City of Ketchum  
Planning & Building

STAFF REPORT  
KETCHUM PLANNING AND ZONING COMMISSION  
REGULAR MEETING OF APRIL 15, 2026

**PROJECT:** Lift View Townhomes

**APPLICATION TYPE:** Design Review and Townhouse Subdivision Preliminary Plat

Figure 2: Building Height Measurement

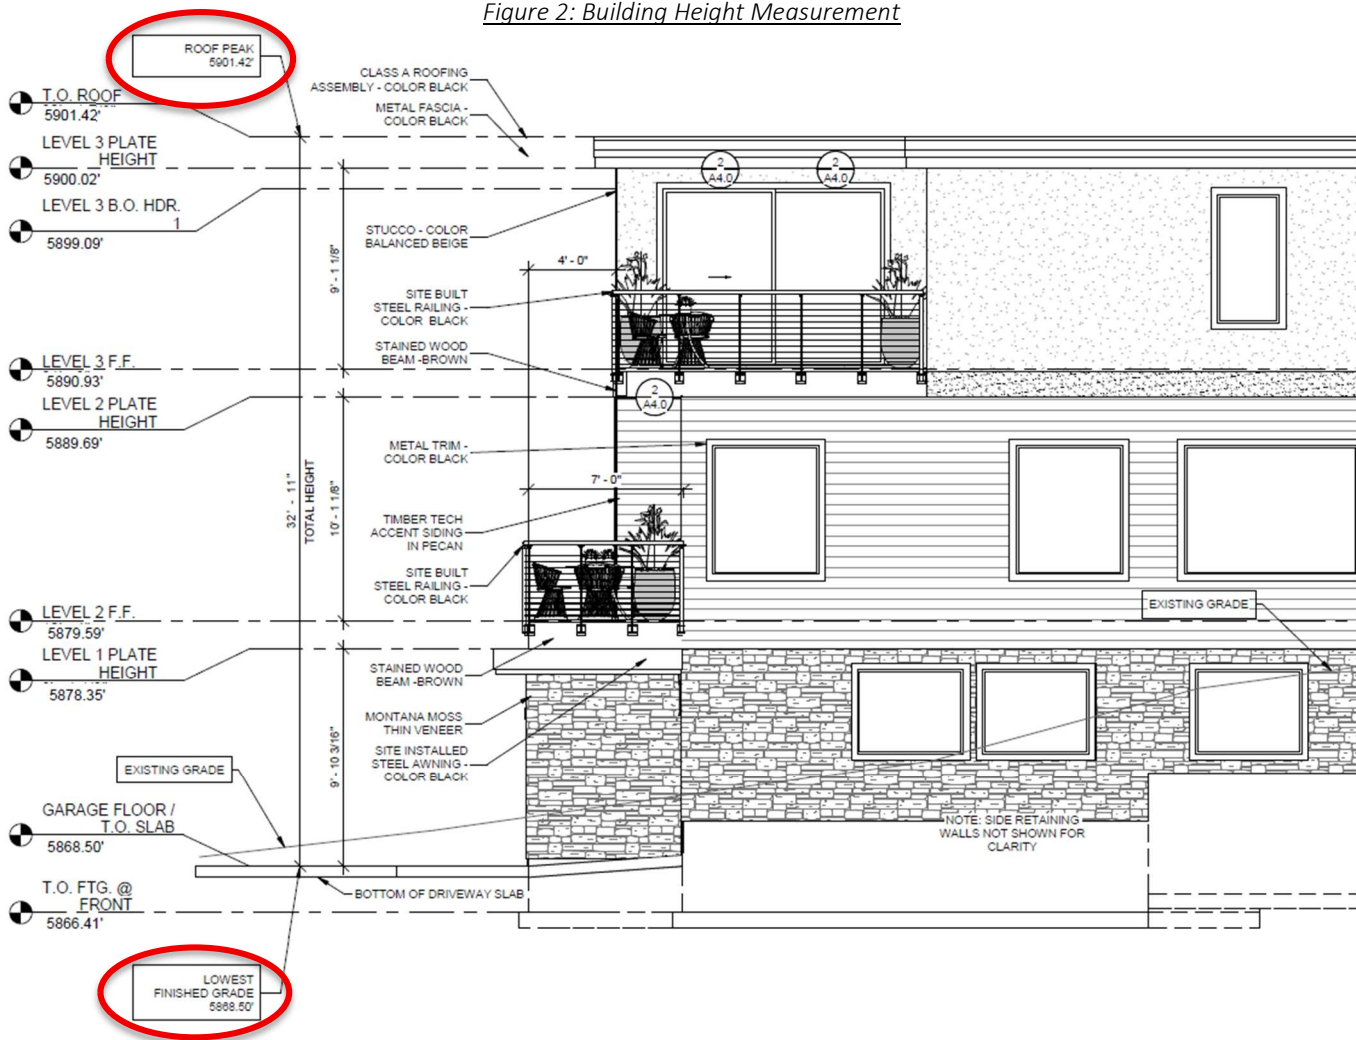
The Commission as well as public comment raised concerns regarding the accuracy of the maximum building height measurement. The Ketchum Municipal Code defines building height as:

The maximum building height is 32'-11", measured from the roof peak elevation of 5,9010.42' and the lowest finished grade elevation of 5,868.50'. The maximum building height has not changed from the previous plan set. Staff believe the concern with the building height was due to the architectural measurements and various labels of the grade on the previous plan set. The applicant revised the elevation sheets (A3.0-A3.3) to now include spot elevations, line of existing grade, and labels to identify the lowest finished grade and roof peak where the building height is measured from. Staff reviewed the building height measurements and believe the height shown on the drawings to be accurate. The building height measurement is shown in Figure 2 below from Sheet A3.1. Additionally, height certificates are required for buildings during the construction period to verify that height limits are not exceeded.

*Figure 3: Previous & Proposed Design Comparison*

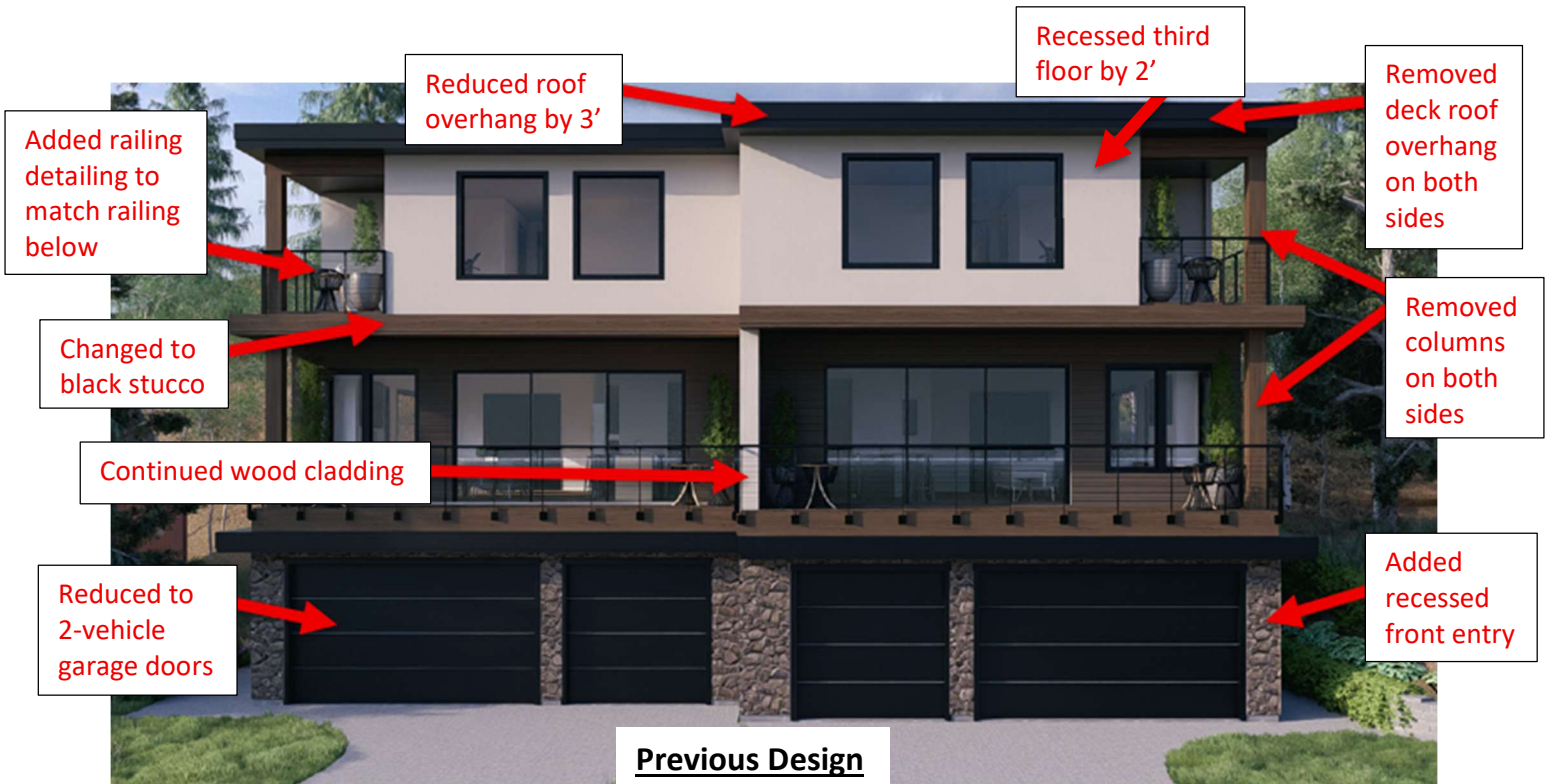
modifications to the design. See Figure 3 below for an evaluation of changes to the previous design and comparison with proposed design.

Please note that the stucco color on the third floor appears darker in the rendering of the proposed design, however it has not changed and remains the color “Balanced Beige” from the previous design, which is indicated on the colors and materials sheet. Also, there was a material callout error on the elevation sheets (A3.0-A3.3) of the revised plan set, which indicates Balanced Beige as the color of the stucco belly band between the second and third floors. The applicant revised those sheets to include a red notation indicating that the correct color of the stucco belly band is Tricorn Black.

FRONT ELEVATION  
1/4" = 1'-0"

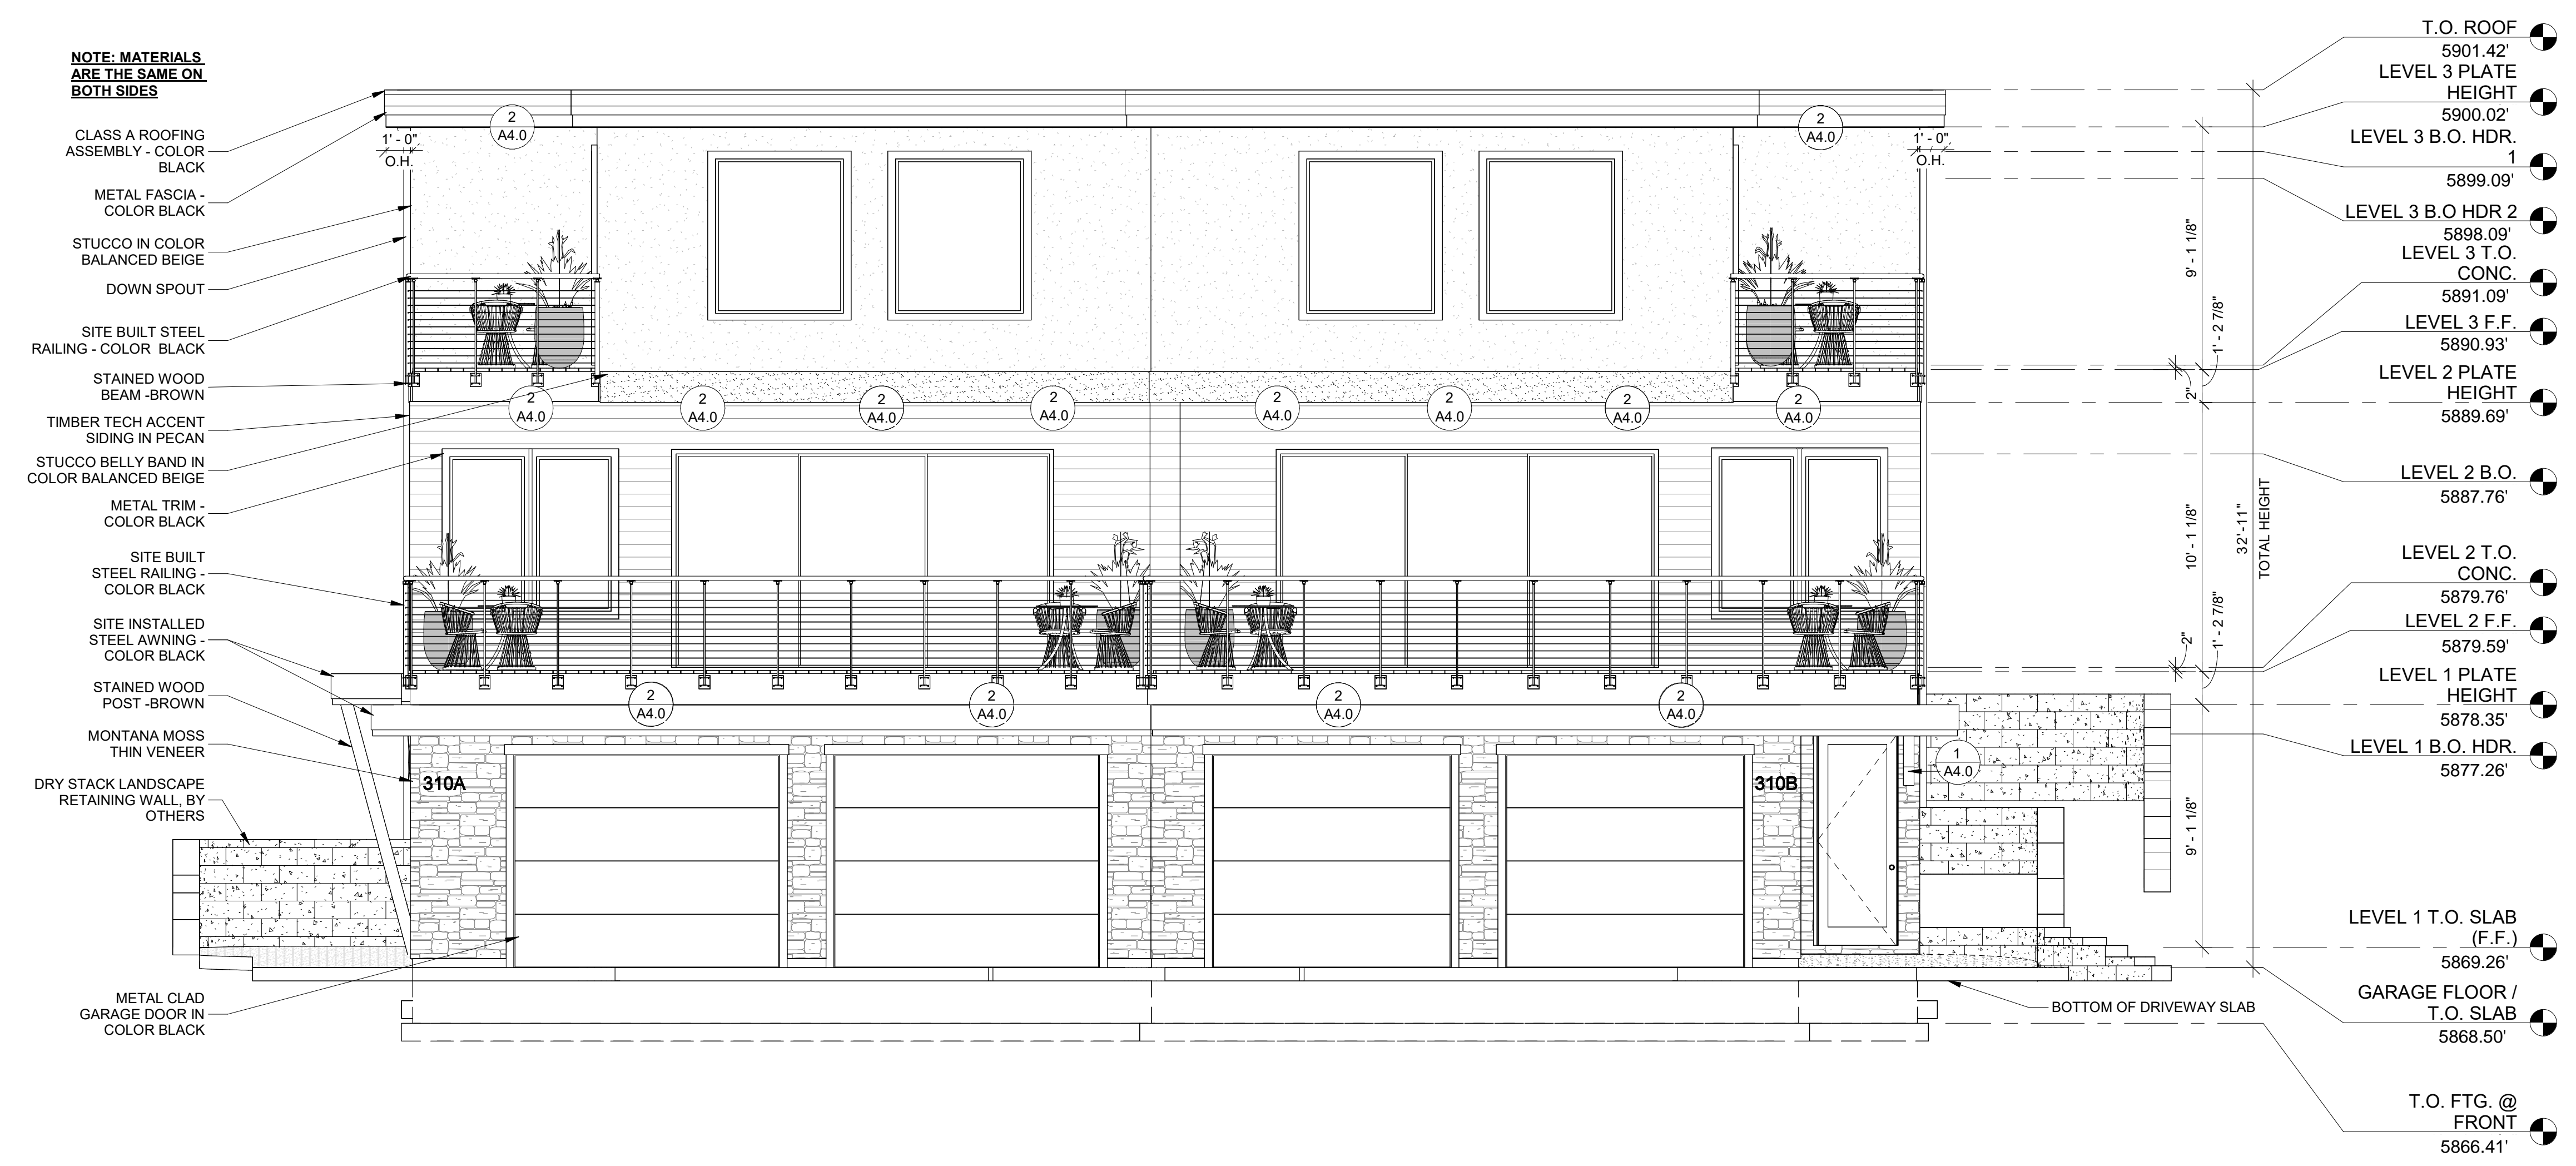
Verify the grade where the maximum building height was measured from and make it clear on the elevation sheets **On each elevation sheet, A3.0-A3.3, the total height is called out with a dimension of 32'-11" from the top of slab at driveway to top of roof, per Ketchum's Municipal Code's definition of building height that states, "The greatest vertical distance measured at any point from the roof to natural, existing, or finished grade, whichever is lowest."**

- Building height remains 32'-11" and was verified by staff. Elevation sheets revised to include spot elevations, line of existing grade, and label identifications of measurement points.

**ROOF PLAN**  
1/4" = 1'-0"

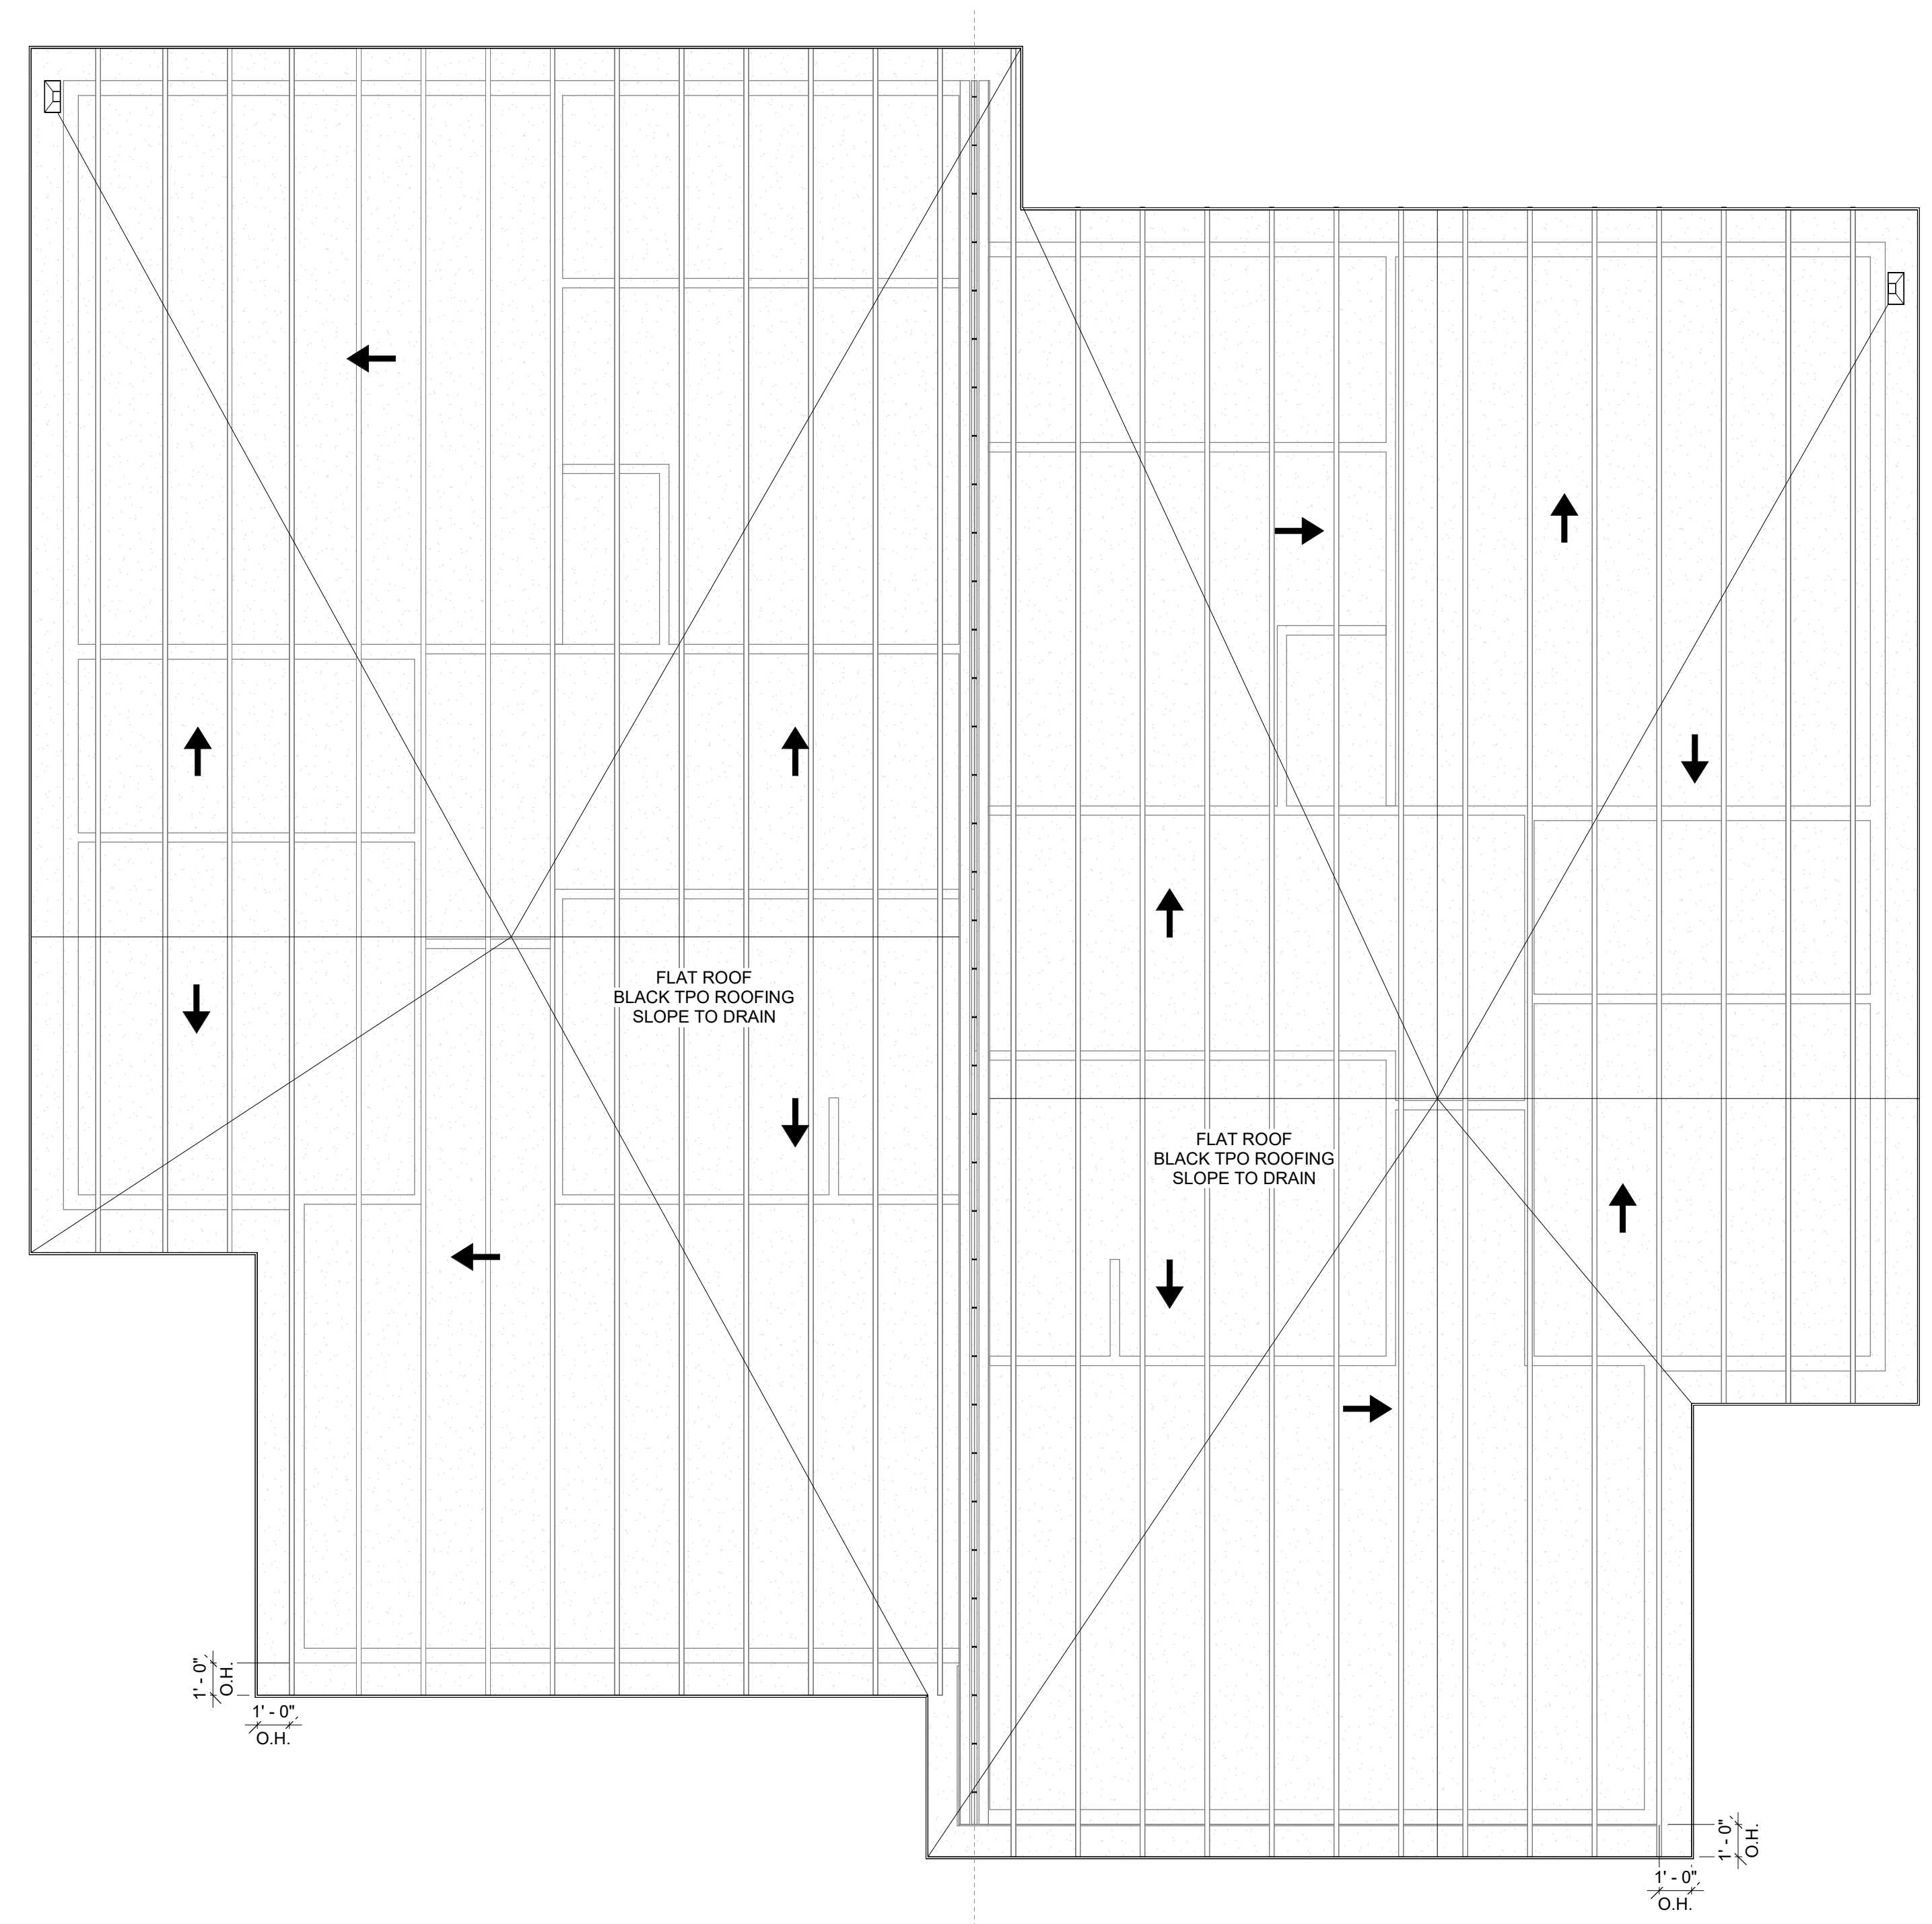
- Indicate downspouts on elevation sheets. Roof drains/downspouts can be seen on sheet A5.0. They can also be seen and/or are called out on sheet A3.0-A3.3.

- Updated landscaping plan to include trees, groundcover, and additional shrubs.
- Other
  - Roof drains and downspouts are now indicated on roof plan and elevation sheets.
